## Cycle Segregation – Slateford Road

Spokes strongly welcomes this project as a way to connect the Spaces for People schemes on Lanark Road, Longstone Road and Dundee Street/Fountainbridge. This provides an enhanced cycle route from the city bypass to the centre of Edinburgh. Slateford Road can be a hostile route to cycle on and the improvements detailed are welcomed.

### **SLA-12727-1100-12**

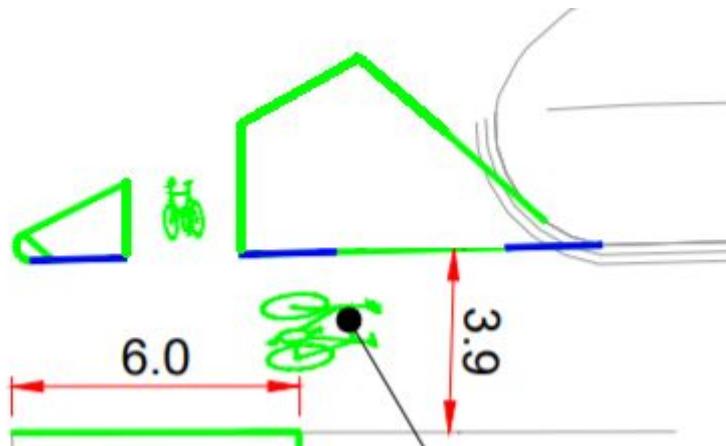
The introduction of segregated cycle lanes in this area is very welcome. Where floating parking/loading bays have been provided, tapering akin to Lanark Road and Comiston Road should be provided wherever possible.
